SERVICE BULLETIN

MODEL NAME : Di620
MODEL CODE : 1155
NO. : 019
DATE : 981215
SUBJECT : HOLDER CHANGE

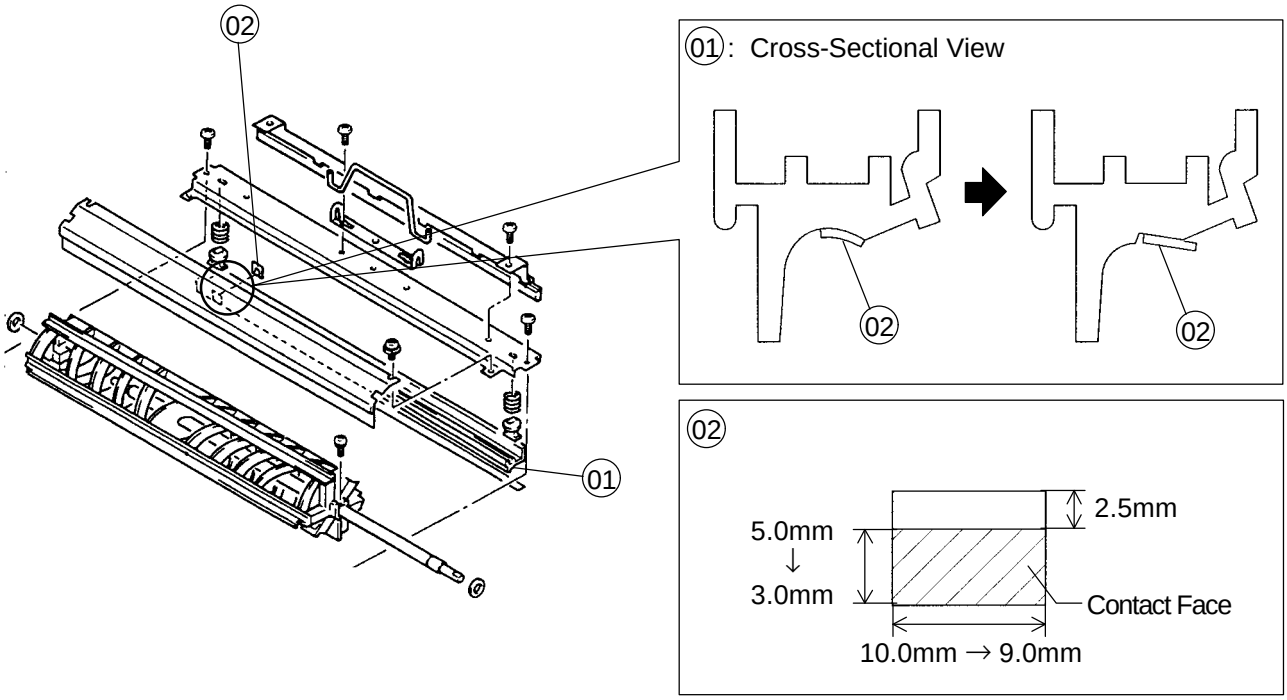
To increase production efficiency, the film affixing face in the holder (01) has been changed from a curved face to a flat face, making the affixing of the polyester film (02) easier. Due to this modification, the dimensions of the polyester film (02) have been changed.

NOTE: The new holder (01) and polyester film (02) must be installed as a set in premodification machines.
